## EASTHAM BUILDING AUDITS

*KMA audited the following buildings:*

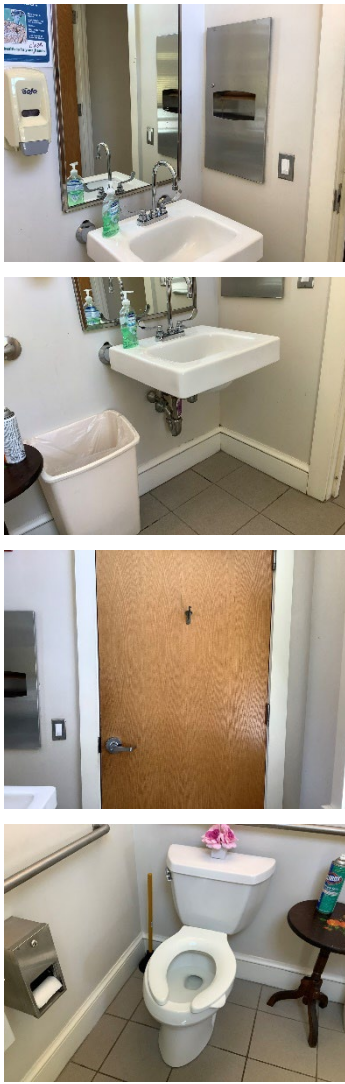
#	Barrier Statement	Photo	Proposed Mitigation	Cost
1.	<p><b>Parking Lot</b></p> <p>Some of the designated accessible parking spaces lack an adjacent access aisle.</p> <p>The designated van accessible aisle is &lt;60" wide, measured centerline to centerline.</p> <p>The isolated accessible parking space have slopes &gt;2%, @ 4.1%</p> <p>The designated accessible parking space facing State Highway is not located on the shortest accessible route to the accessible entrance.</p> <p>The accessible parking signs are mounted &lt;60" AFF, measured to the bottom of the sign, @ 40" AFF.</p>		<p>Restripe the pavement markings in the group of three parking spaces and associated access aisles. Unit Cost: \$150 per space or aisle Quantity: 5 (3 spaces, 2 aisles)</p> <p>Restripe and relocate the space closest to the accessible entrance, as well as its associated sign and access aisle, to make 1 van accessible space. Unit Cost: \$300 per space or aisle Quantity: 2 (1 space, 1 aisle)</p> <p>Install a sign with the International Symbol of Accessibility at 60" AFF minimum, measured to the bottom of the sign. Include a van accessible sign where applicable. Unit Cost: \$100 ea. Quantity: 4</p>	\$1,750

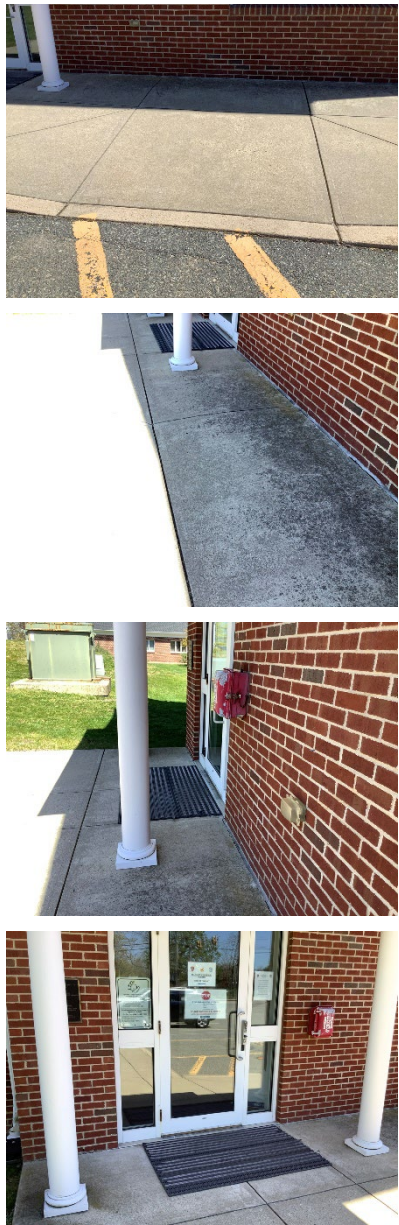
#	Barrier Statement	Photo	Proposed Mitigation	Cost
1.	<p><b>Parking Lot</b></p> <p>The accessible parking sign is mounted &lt;60" AFF, measured to the bottom of the sign, @ 40" AFF.</p> <p>The access aisle has changes in level &gt;1/4" due to variations in the paver surface and to sewer covers.</p>	 <p>The top photo shows a blue accessible parking sign mounted on a post that is too low to the ground. The middle photo shows a raised curb at the edge of a parking space. The bottom photo shows a circular sewer cover in the middle of a parking aisle.</p>	<p>Install a van accessible parking sign with the International Symbol of Accessibility at 60" AFF minimum, measured to the bottom of the sign.            Unit Cost: \$100 ea.            Quantity: 1</p> <p>Regrade the aisle.            Unit Cost: \$1,500 per space or aisle            Quantity: 1 space</p>	\$1,600

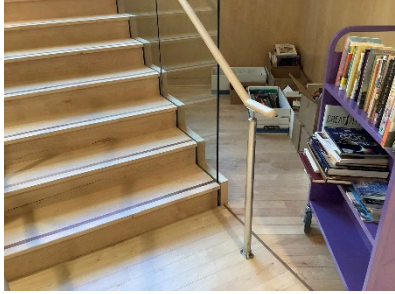
<p>3.</p>	<p><b>Outdoor Elements</b></p> <p>There is no accessible route to the trash due to the bicycle rack.</p> <p>There is no level 30" x 48" clear floor space adjacent to the trash, @ 30" x 34".</p> <p>The outdoor table located on the lower terrace is not accessible.</p>	 	<p>Relocate the trash to provide the required clear floor space along an accessible route. Unit Cost: \$250 ea. Quantity: 1</p> <p>Provide at least one table, and no less than 5% of the total number of tables, that provides compliant knee and toe clearance. Unit Cost: \$250 ea. Est. Quantity: 1</p>	<p>\$500</p>
<p>4.</p>	<p><b>Lower Terrace Door</b></p> <p>The door maneuvering clearance is &lt;12" on the latch push-side for a forward approach, @ 6".</p>		<p>Install an automatic door opener. Unit Cost: \$2,500 ea. Quantity: 1</p>	<p>\$2,500</p>
<p>5.</p>	<p><b>Outdoor Stairs</b></p> <p>The stair has a compliant handrail on only one side.</p>		<p>Install a compliant handrail on the second side. Unit Cost: \$50/LF Est. Quantity: 64 LF</p>	<p>\$3,200</p>

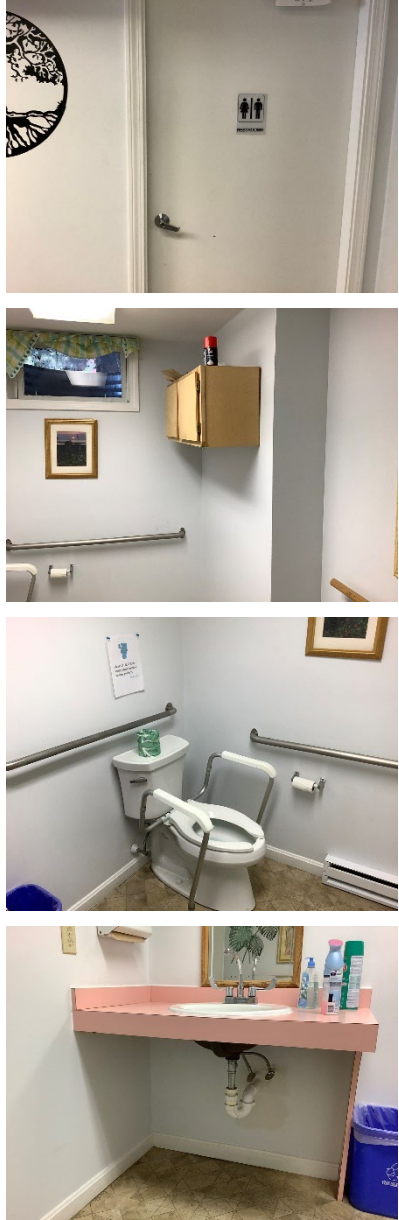
<p>2.</p>	<p><b>Upper Parking Lot</b></p> <p>The pavement markings in the designated parking spaces are not visible.</p> <p>The designated accessible parking spaces lack an adjacent access aisle.</p> <p>There is an insufficient number of van accessible parking spaces. For a parking lot with 3 accessible spaces, 1 must be van accessible.</p> <p>Some of the accessible parking spaces have slopes &gt;2%, @ 3%.</p> <p>The accessible parking signs are mounted &lt;60" AFF, @ 50" AFF measured to the bottom of the sign.</p>		<p>Regrade and restripe the existing accessible parking space and associated access aisle. Unit Cost: \$1,500 per space or aisle Quantity: 2 (1 space, 1 aisle)</p> <p>Restripe the existing accessible parking spaces and associated access aisles. Add 1 van accessible space, as well as its associated sign and access aisle. Unit Cost: \$1,500 per space or aisle Quantity: 5 (3 spaces, 2 aisle)</p> <p>Install a sign with the International Symbol of Accessibility at 60" AFF minimum, measured to the bottom of the sign. Include a van accessible sign where applicable. Unit Cost: \$100 ea. Quantity: 4</p>	<p>\$10,900</p>

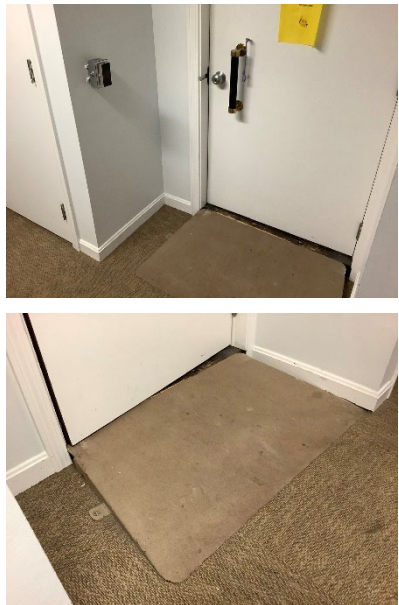
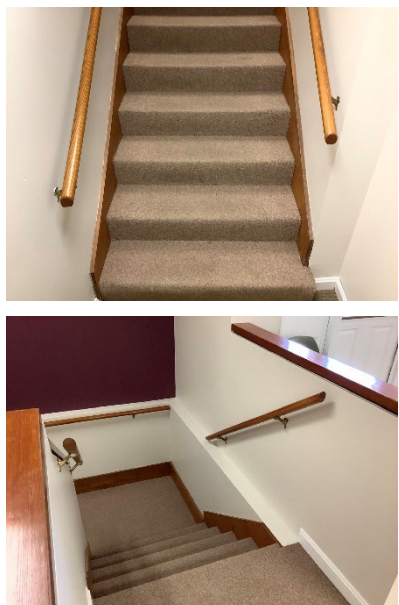
<p>6.</p>	<p><b>Secondary Entrance at Conference Room</b></p> <p>The ramp has cross slopes &gt;2%, @ 5%.</p> <p>The bottom ends of the handrails are neither rounded nor returned to floor, wall, or post, as required by 521 CMR.</p> <p>There is an abrupt change in level at the bottom of the ramp.</p>		<p>Rebuild the ramp, including compliant handrails.</p> <p>Unit Cost: \$15,000 ea.</p> <p>Quantity: 1</p>	<p>\$15,000</p>
-----------	---	---	---	-----------------

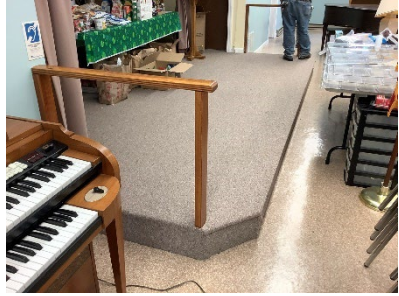
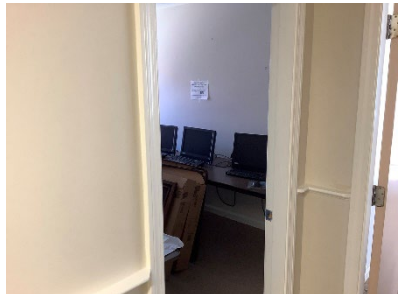
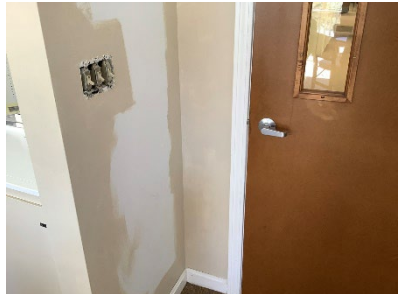
<p>7.</p>	<p><b>Secondary Entrance at Reception Area</b></p> <p>The top half of the ramp has running slopes &gt;8.3%, @ 9%.</p> <p>The ramp lacks the required upper and lower handrail extensions.</p> <p>The bottom ends of the handrails are neither rounded nor returned to floor, wall, or post, as required by 521 CMR.</p> <p>The handrails are not continuous.</p> <p>The ramp handrails are not mounted 34"-38" AFF, @ 33" AFF.</p>		<p>Rebuild the ramp, including compliant handrails.</p> <p>Unit Cost: \$15,000 ea.</p> <p>Quantity: 1</p>	<p>\$15,000</p>
<p>8.</p>	<p><b>Secondary Entrance at Ground Floor Hallway</b></p> <p>The inaccessible secondary entrance (C) lacks directional signage to the accessible entrance.</p> <p>The bottom ends of the handrails are neither rounded nor returned to floor, wall, or post, as required by 521 CMR.</p>		<p>Provide directional signage to the accessible entrance.</p> <p>Unit Cost: \$100 ea.</p> <p>Est. Quantity: 1</p> <p>Install compliant handrails on both sides.</p> <p>Unit Cost: \$50/LF</p> <p>Est. Quantity: 10 LF</p>	<p>\$600</p>
